**RFT 26-085 Interior Renovations and Elevator Addition - King's Road PS**

**The following, issued by the Halton District School Board (HDSB) September 2, 2026, shall be incorporated in the specifications and shall form part of the proposal document for the above.**

1. Bidders are asked to review the attached Addendum # 1 as drafted by WK Lim Architects Inc. (195 pages).
2. **REVISED FORM OF TENDER:**
  - a. Bidders are asked to review the attached Revised Form of Tender. All bids must be submitted using the attached Revised Form of Tender (2 pages).

**SECTION DETAIL**

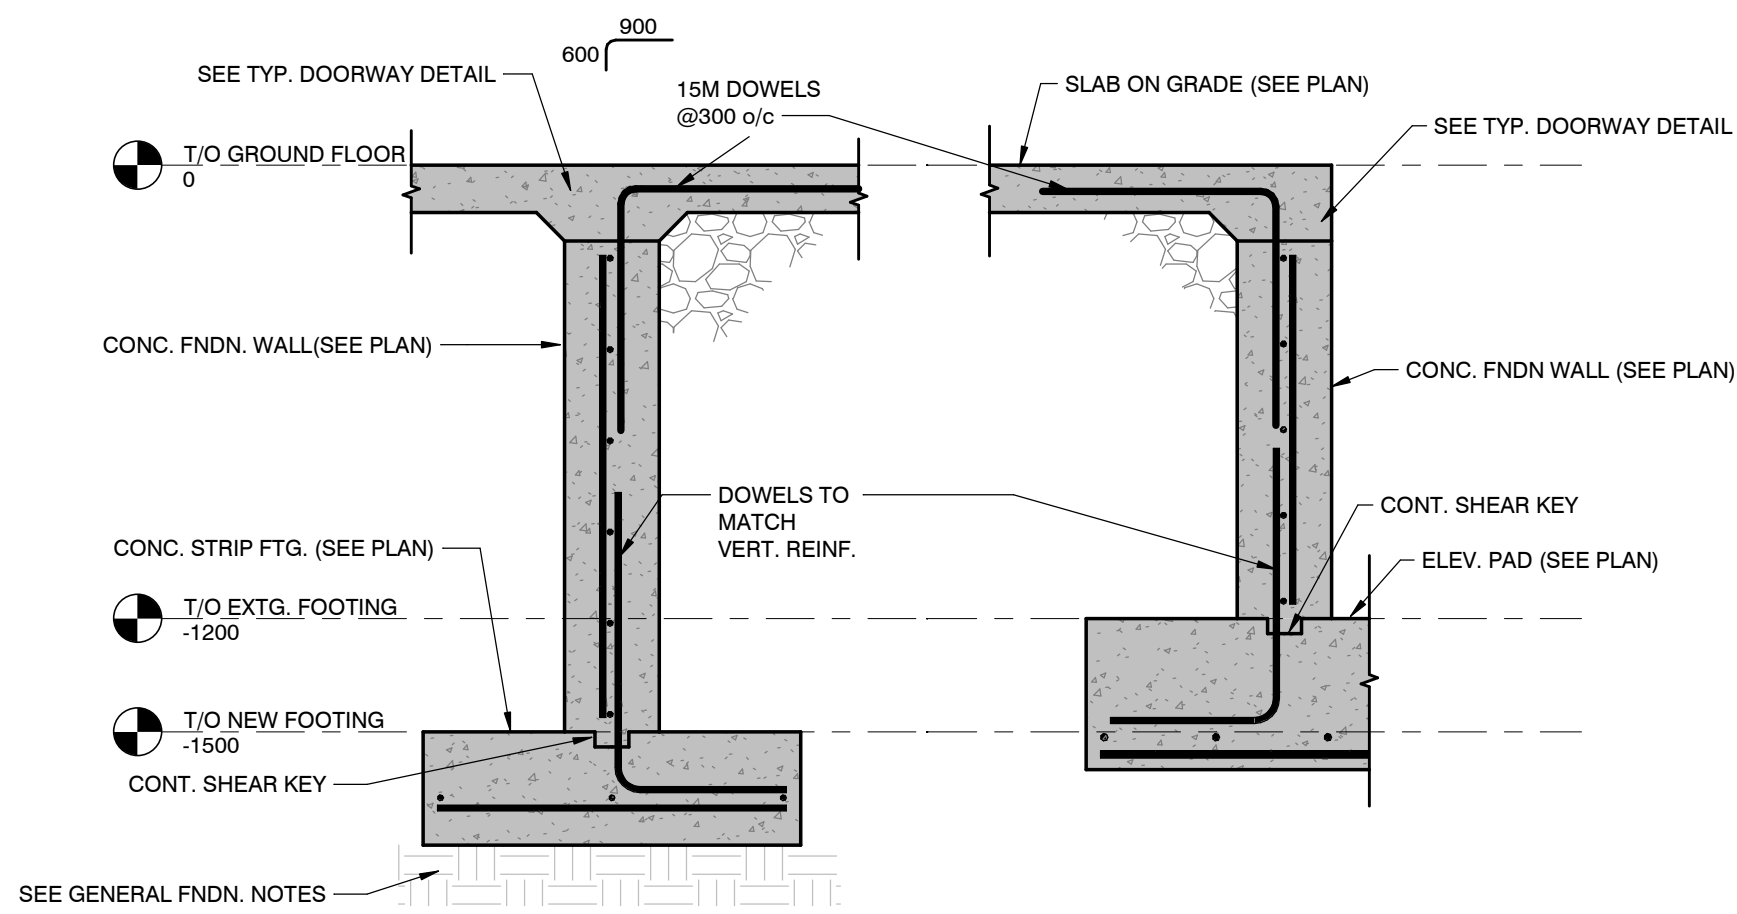
Please provide structural section detail through the vestibule in the foundation plan (S2.0) to further understand scope of work.

**ADDITIONAL STRUCTURAL DETAILS**  
Drawings S2.0 and S2.1 revised August 28, 2026 (attached).

Description: Refer to Drawings S2.0 and S2.1, issued by MTE Consultants, revised August 28, 2026 (attached).
